**METROPOLITAN GOVERNMENT OF NASHVILLE AND DAVIDSON COUNTY**

**STAFF RECOMMENDATION**  
**1415 4<sup>th</sup> Avenue North**  
**October 21, 2020**

**Application:** New Construction—Addition  
**District:** Germantown Historic Preservation Zoning Overlay  
**Council District:** 19  
**Map and Parcel Number:** 082090T01300  
**Applicant:** Benjamin Katz  
**Project Lead:** Melissa Baldock, melissa.baldock@nashville.gov

Figure 1. 1415 4<sup>th</sup> Ave N.

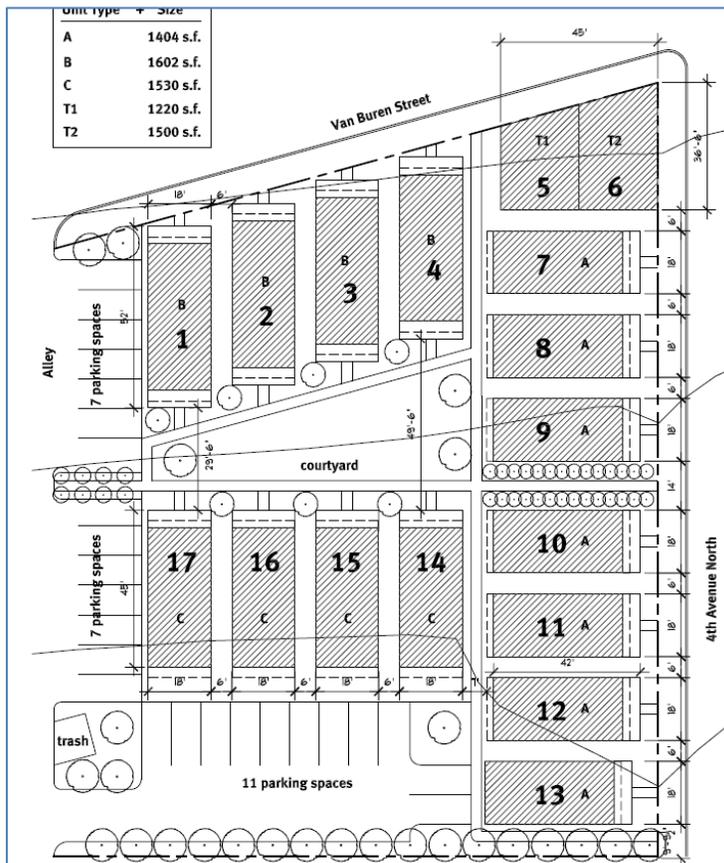
**Background:** 1415 4<sup>th</sup> Avenue North was constructed c. 2010 and is a part of a 17-structure development known as Germantown Station (Figure 1). MHZC approved the project in 2010 (Figure 2). The development was done under the existing MUN development and is not part of a Specific Zoning Plan.

Figure 3. The spacing between 1415 4<sup>th</sup> Avenue north and its neighbor at 1407 4<sup>th</sup> Avenue North.

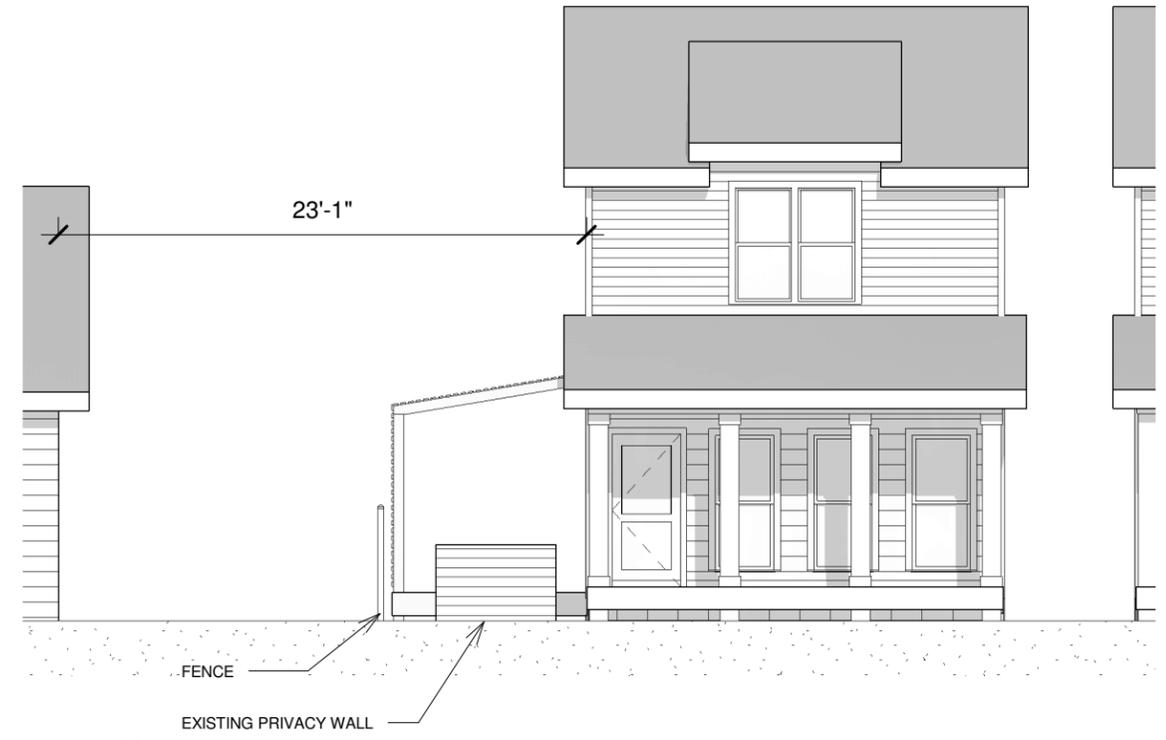
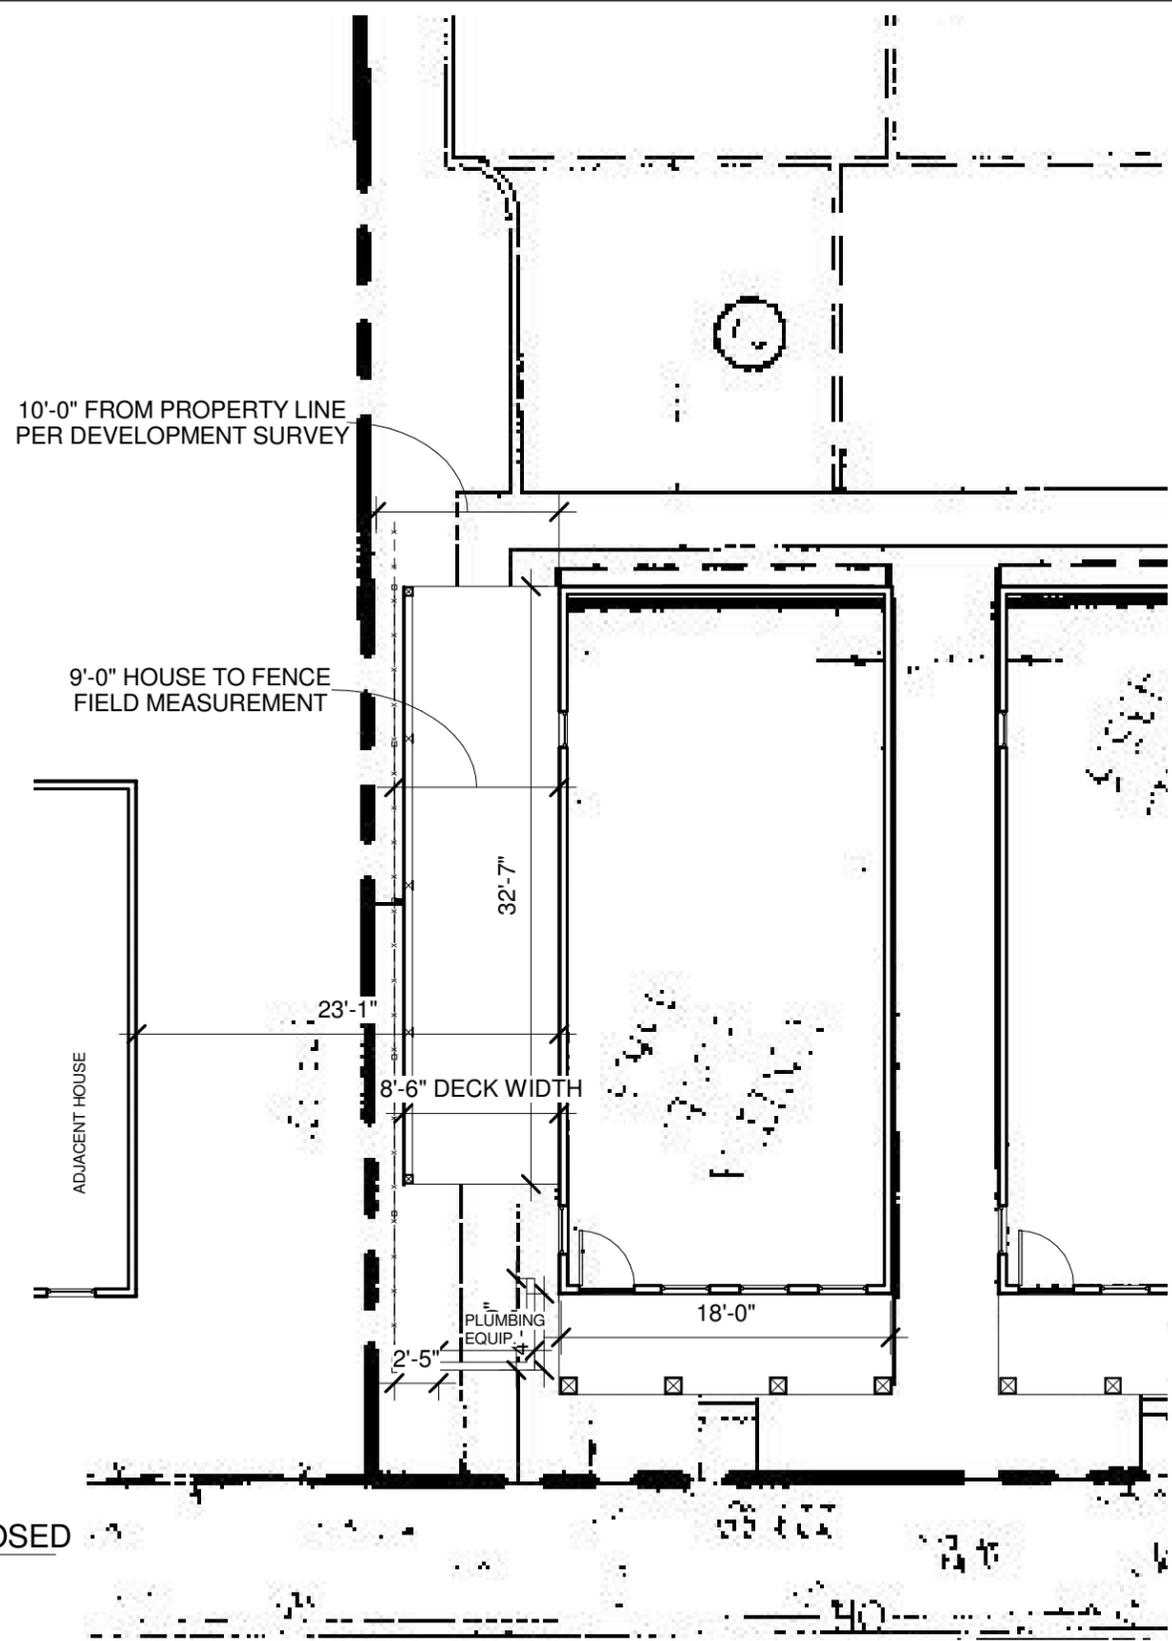
Location: The addition is proposed on the left side of the house. It will be six feet (6') behind the front wall of the house and eleven feet (11') behind the wall of the porch. It will be visible from the street. The design guidelines states that side additions can be appropriate when lots are wider than sixty feet (60'). Although the development's lot is over sixty feet (60') wide, the portion of the lot that this particular house has is just about thirty feet (30') wide.

Although the house is non-contributing, staff finds that the side addition does not meet the design guidelines and the historic context because the house is part of a larger development. At the time the Commission approved the plan for the overall development, the project was already quite large and the structures closely located. Increasing the size of these structures, particularly to the side where the additions will be highly visible, is not appropriate because the development is already quite dense. While MUN does not have a required side setback, the Commission approved the existing left side setback of ten feet (10') in 2010 so that there could be adequate space between the dense townhouse development and the historic houses to the left of the development along 4<sup>th</sup> Avenue North (Figure 3). Staff finds it is not appropriate to reduce the side setback further with this proposed side porch addition.

Staff finds that the proposed addition does not meet Sections V.B.3.a. and V.B.3.d. of the design guidelines.

3 Proposal - Front  
1/8" = 1'-0"

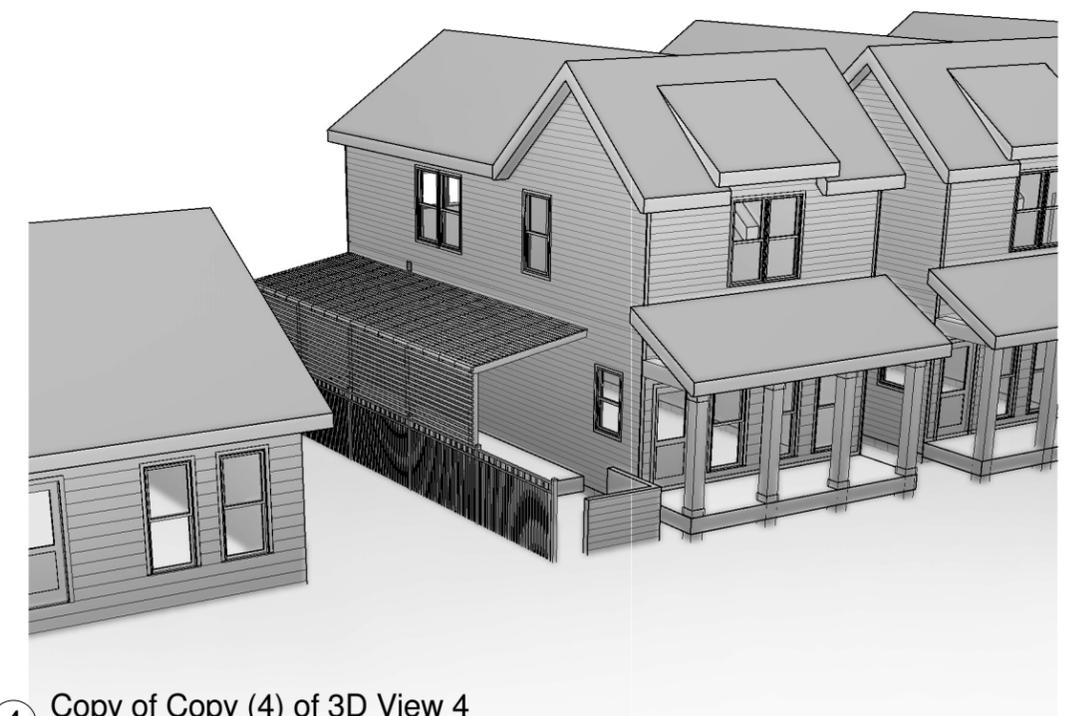
Massing, Scale, and Height: The existing house is two stories and the proposed addition is just one story in height. The height of the porch will be approximately ten feet, six inches (10'6"). The porch addition is proposed to be eight feet, six inches (8'6") wide and thirty-two feet, seven inches (32'7") deep, for a total footprint of approximately two hundred and seventy-seven square feet (277 sq. ft.). If one just looks at the house on its own, this size addition could be appropriate. However, because this house is part of a

Materials: The addition is a simple open porch with wood posts and a wood deck floor. The covering material for the roof and left side wall was not indicated on the plans. Should the Commission approve the side porch addition, staff recommends that a condition of approval be that staff approve the material of the roof and left side wall prior to the issuance of the preservation permit.

Roof: The roof of the addition will be a simple 2/12 shed roof, which is appropriate for a porch addition like this one to a non-contributing structure.

Design: If this house was on its own lot with ample room for a side addition, then its design would be compatible to the house and overall district. However, because this house is part of a larger, dense development, staff finds that its design does create an overall development that is in scale with the historic neighborhood. The addition's location so close to the side property line is not in keeping with the setbacks the Commission approved for the development in 2010.
